Groundwater Application Review Summary Form

Application # G- 19300

GW Reviewer Stacey Garrison/Travis Brown Date Review Completed: 8/16/2023

TO: Water Rights Section Date 9/25/2023
 FROM: Groundwater Section Stacey Garrison/Travis Brown
 Reviewer's Name
 SUBJECT: Application G- 19300 Supersedes review of _____
 Date of Review(s) _____

Water-Level Measurements in Nearby Wells

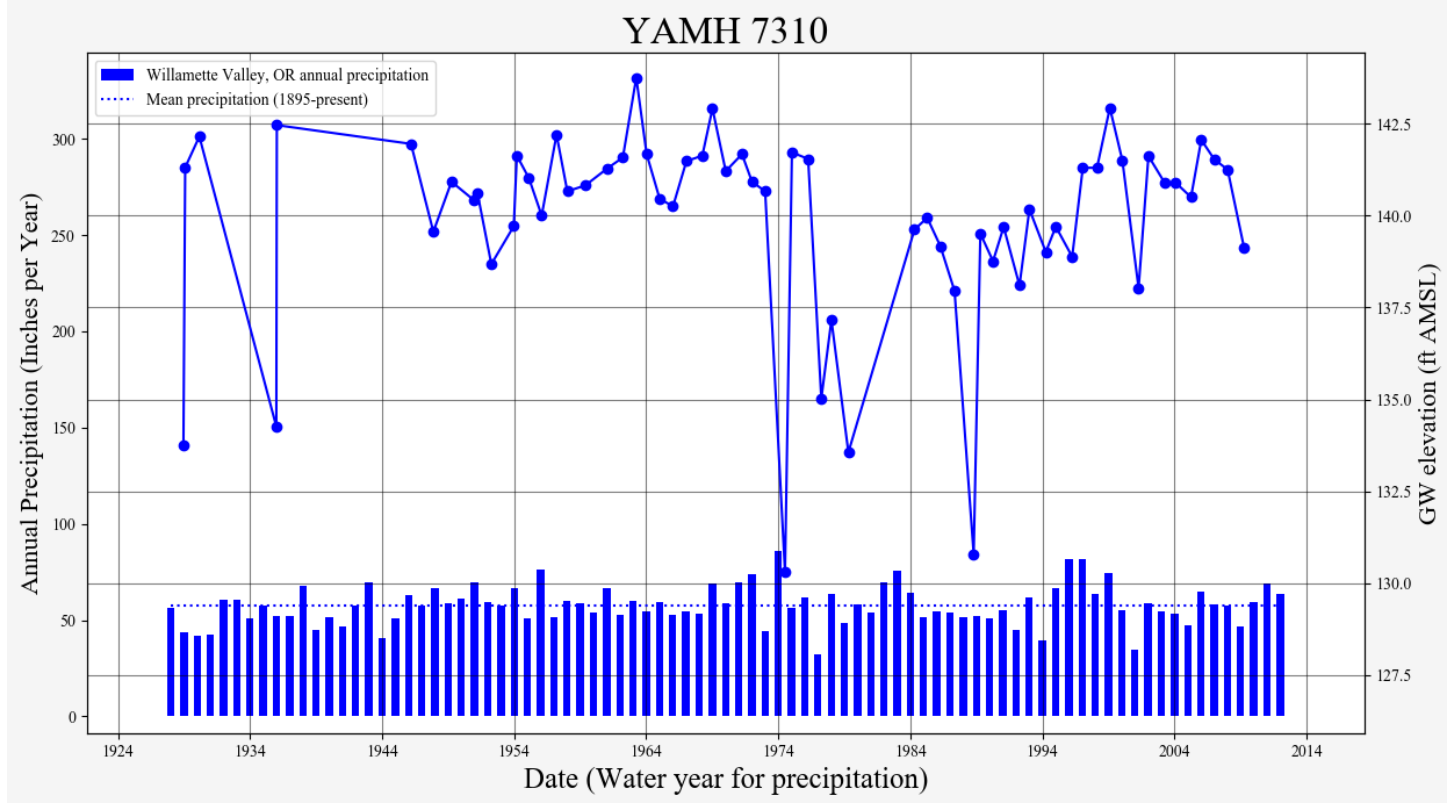
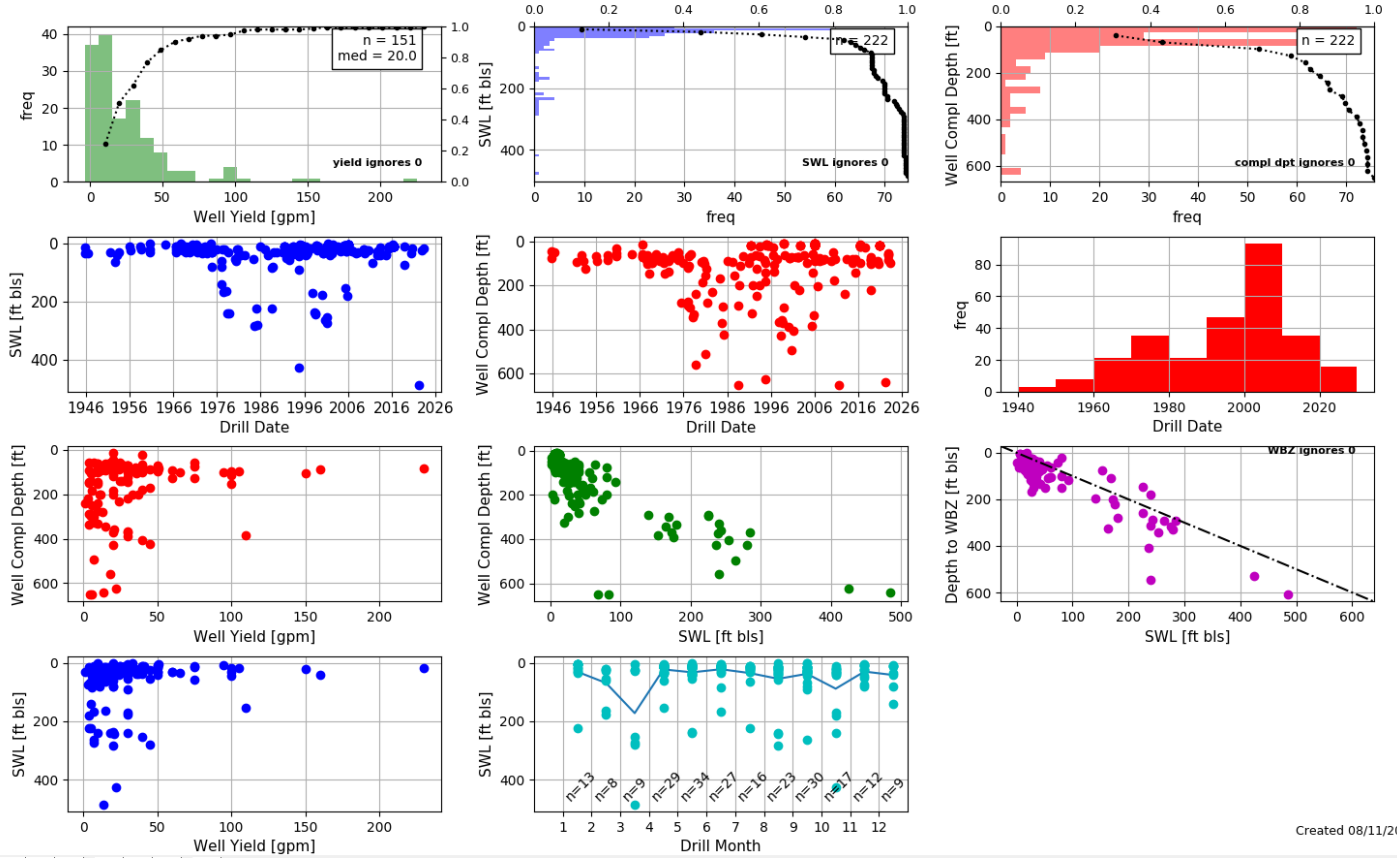
Water levels are declining (see Water Level Measurements in Nearby Wells). For the 6 QLTS observation wells within 3 miles of the POAs that have SWL data in the last 20 years, only 2 have data within the last 5 years (YAMH 453, YAMH 57192) with only 1 additional well with data in the last 10 years (YAMH 6888). While YAMH 6888 shows an increase in water levels over its entire record, the wells with more recent data show declines of 3 ft in the last 5 years. One well has an extended record from 1928 to 2009 (YAMH 7310) showing a 7 ft drop over its entire record. Within 1 mile of the POAs, there are 12 authorized POAs for 13 groundwater rights, including 3 municipal water rights. There is not a preponderance of evidence to indicate the groundwater resource is over-appropriated.

**Theis Drawdown Analysis
POA 1**

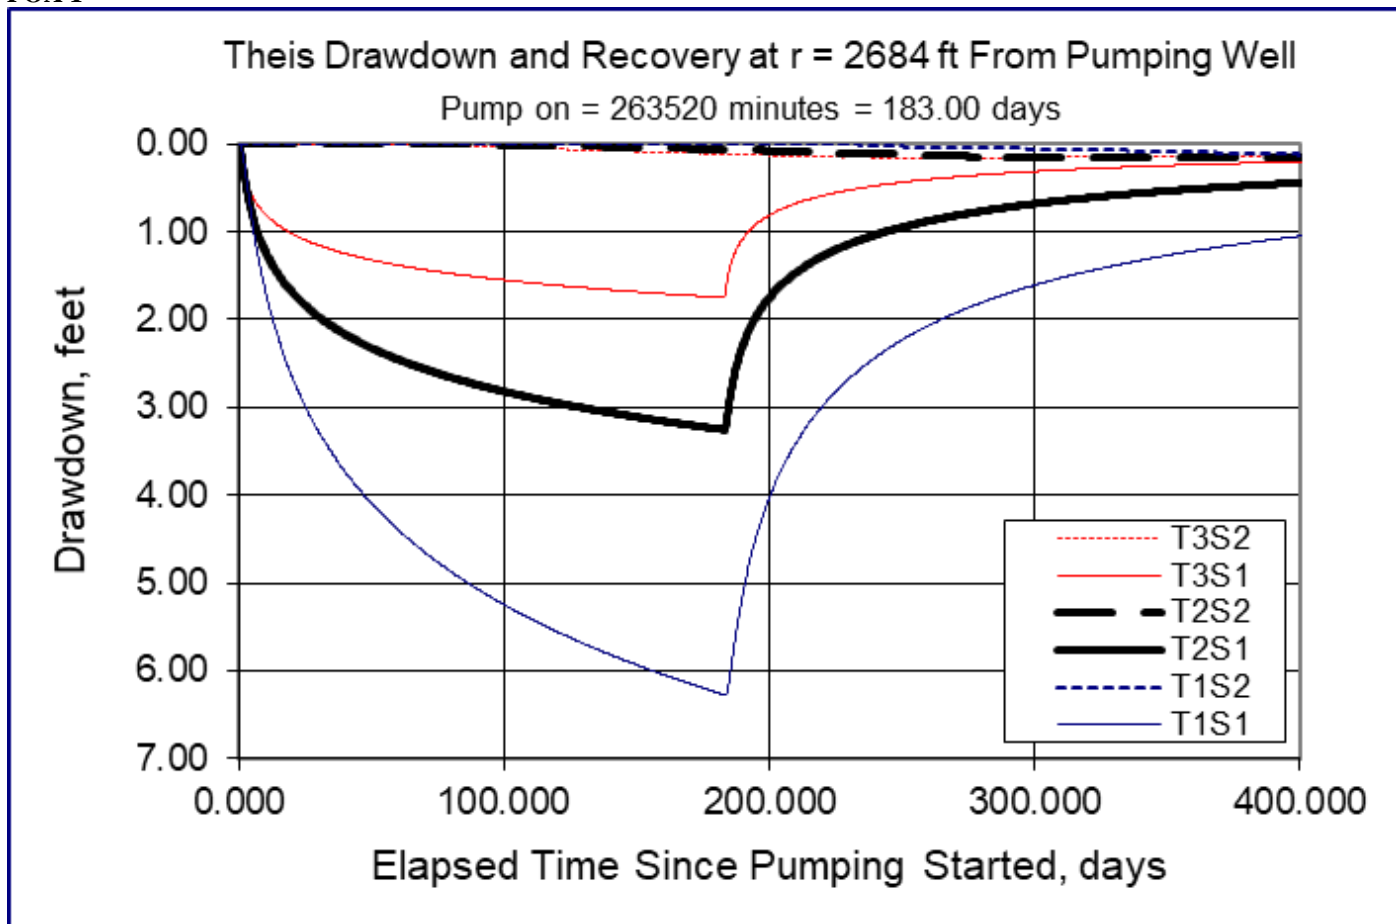
The nearest groundwater user to POA 1 is YAMH 1799 (an exempt use well) 2,684 ft southeast of the POA at an elevation of 162 ft msl. It is likely the proposed use would cause some degree of well-to-well interference with YAMH 1799. To assess the degree of drawdown, a Theis drawdown analysis was conducted for the proposed use (see attached Theis Drawdown Analysis-POA 1). Results indicate that the proposed use is not likely to cause well-to-well interference with YAMH 1799 that exceeds the threshold under the standard condition for alluvial aquifers in the Willamette Basin.

Radial distance from pumping well (r)=2,684 ft [estimated radial distance to nearest user, YAMH 1799]

Pumping Rate (Q)= 0.129 cfs (~58.11 gpm)*

Aquifer Transmissivity (T1)= 3,837 gpd/ft (513 ft²/day), (T2)= 9,159 gpd/ft (1,224 ft²/day), (T3)= 19,979 gpd/ft (2,671 ft²/day)

Storativity (s1) = 0.0008, (s2) = 0.2 [Conlon et al 2005, Table 1 values for Middle Sedimentary Unit, MSU]

*The full pumping rate could not be utilized continuously for the entire 183-day period of use without exceeding the 47 ac-ft maximum allowed duty. For the maximum allowed duty of 47 ac-ft, continuous pumping would occur for 183 days at a rate of 0.129 cfs (~58.11 gpm).

Based on this analysis of the available data and under the assumptions previously identified, groundwater for the proposed use is likely within the capacity of the resource; if a permit is issued for this application, the conditions in B1(d)(i) and B2(c) are recommended to protect senior users and the groundwater resource.

POA 2

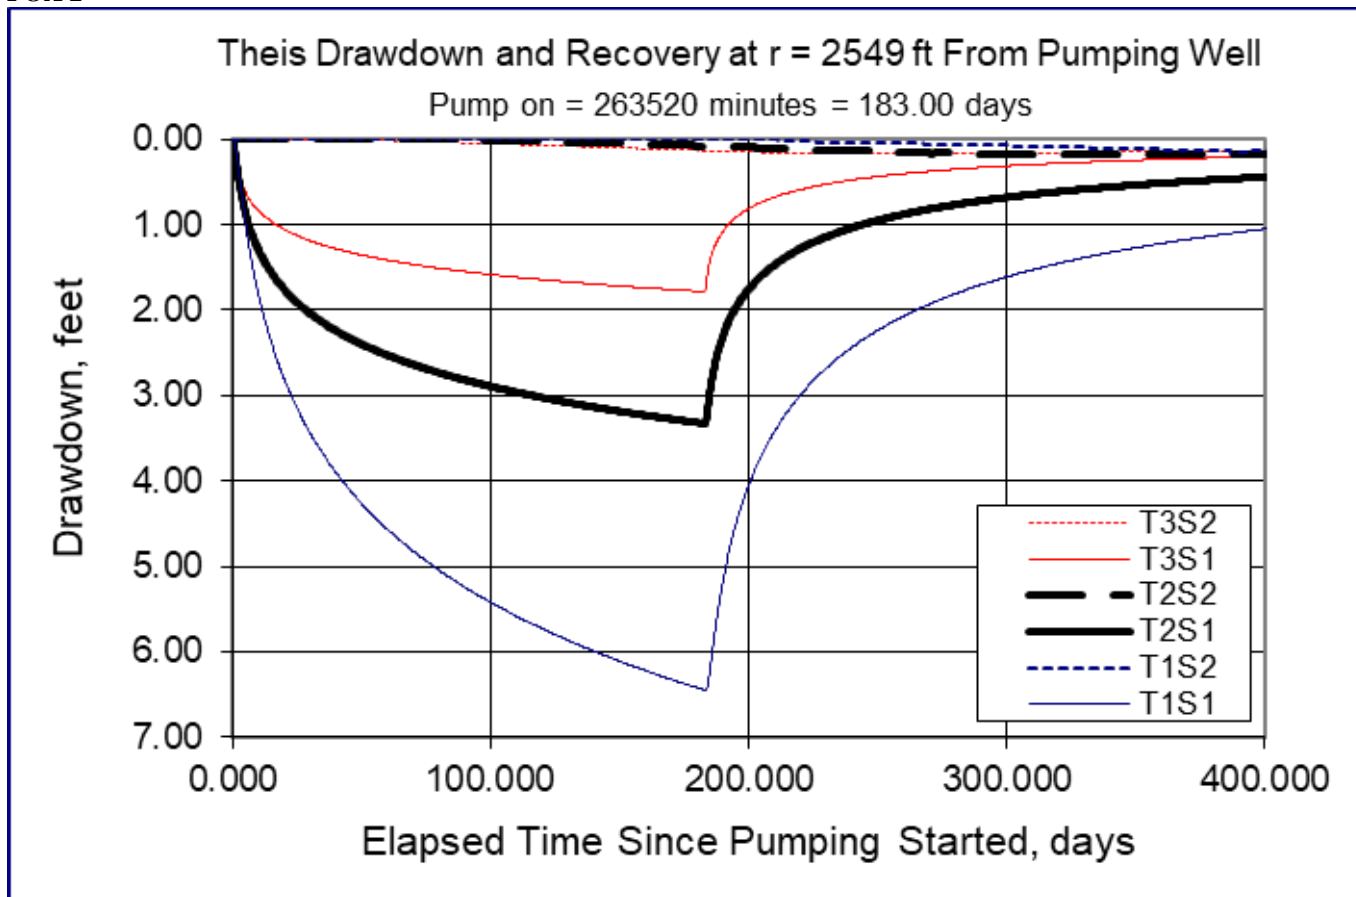
The nearest groundwater user to POA 2 is YAMH 1799 (an exempt use well) 2,549 ft southeast of the POA at an elevation of 162 ft msl. It is likely the proposed use would cause some degree of well-to-well interference with YAMH 1799. To assess the degree of drawdown, a Theis drawdown analysis was conducted for the proposed use (see attached Theis Drawdown Analysis-POA 2). Results indicate that the proposed use is not likely to cause well-to-well interference with YAMH 1799 that exceeds the threshold under the standard condition for alluvial aquifers in the Willamette Basin.

Radial distance from pumping well (r)=2,549 ft [estimated radial distance to nearest user, YAMH 1799]

Pumping Rate (Q)= 0.129 cfs (~58.11 gpm)*

Aquifer Transmissivity (T1)= 3,837 gpd/ft (513 ft²/day), (T2)= 9,159 gpd/ft (1,224 ft²/day), (T3)= 19,979 gpd/ft (2,671 ft²/day)

Storativity (s1) = 0.0008, (s2) = 0.2 [Conlon et al 2005, Table 1 values for Middle Sedimentary Unit, MSU]

*The full pumping rate could not be utilized continuously for the entire 183-day period of use without exceeding the 47 ac-ft maximum allowed duty. For the maximum allowed duty of 47 ac-ft, continuous pumping would occur for 183 days at a rate of 0.129 cfs (~58.11 gpm).

POA 3

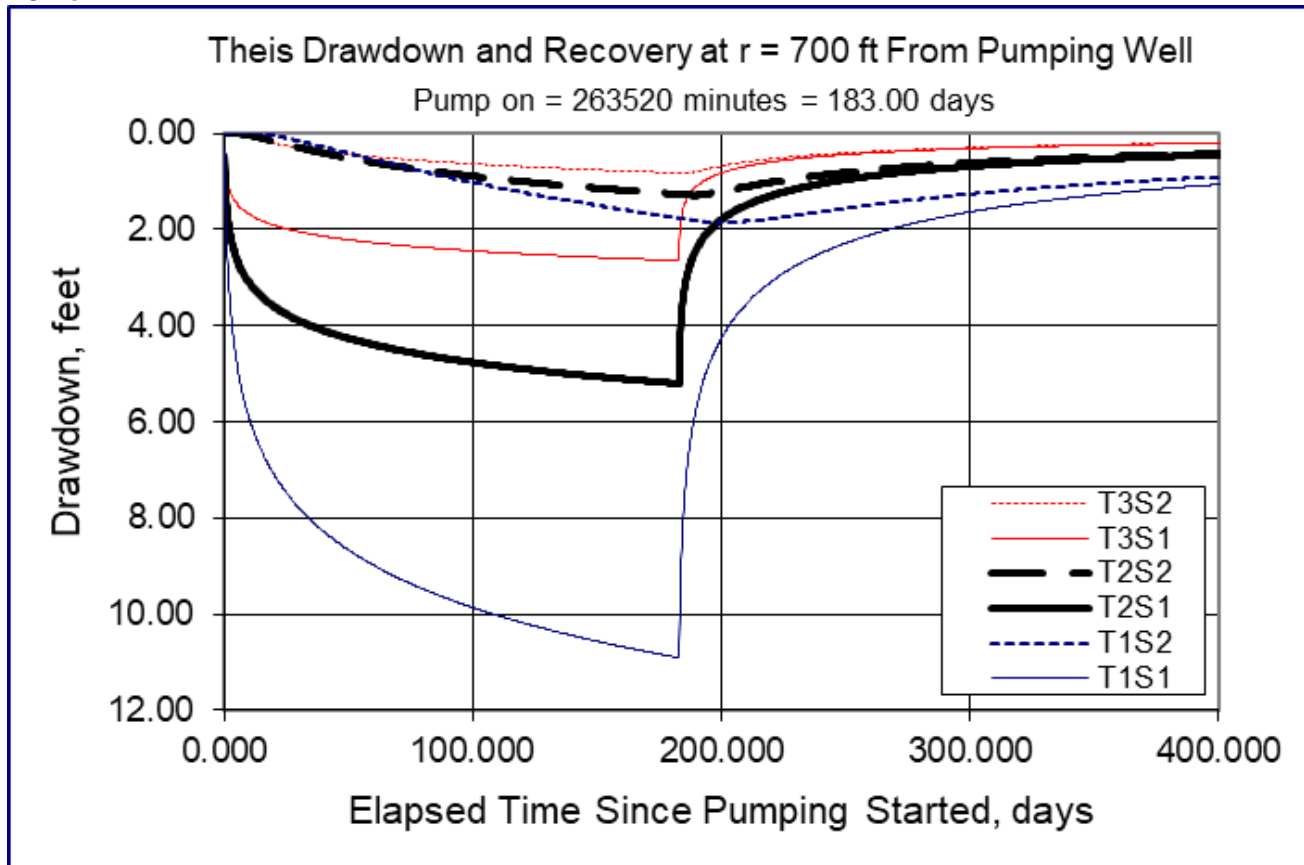
The nearest groundwater user to POA 3 is the exempt domestic use well that serves tax lot 800 at 10875 SW Lancefield Rd, ~700 ft south of the POA at an elevation of 163 ft msl. It is likely the proposed use would cause some degree of well-to-well interference with the well that serves tax lot 800. To assess the degree of drawdown, a Theis drawdown analysis was conducted for the proposed use (see attached Theis Drawdown Analysis-POA 2). Results indicate that the proposed use is not likely to cause well-to-well interference with well that serves tax lot 800 that exceeds the threshold under the standard condition for alluvial aquifers in the Willamette Basin.

Radial distance from pumping well (r)=700 ft [estimated radial distance to nearest user, Domestic well at tax lot 800]

Pumping Rate (Q)= 0.129 cfs (~58.11 gpm)*

Aquifer Transmissivity (T1)= 3,837 gpd/ft (513 ft²/day), (T2)= 9,159 gpd/ft (1,224 ft²/day), (T3)= 19,979 gpd/ft (2,671 ft²/day)

Storativity (s1) = 0.0008, (s2) = 0.2 [Conlon et al 2005, Table 1 values for Middle Sedimentary Unit, MSU]

*The full pumping rate could not be utilized continuously for the entire 183-day period of use without exceeding the 47 ac-ft maximum allowed duty. For the maximum allowed duty of 47 ac-ft, continuous pumping would occur for 183 days at a rate of 0.129 cfs (~58.11 gpm).
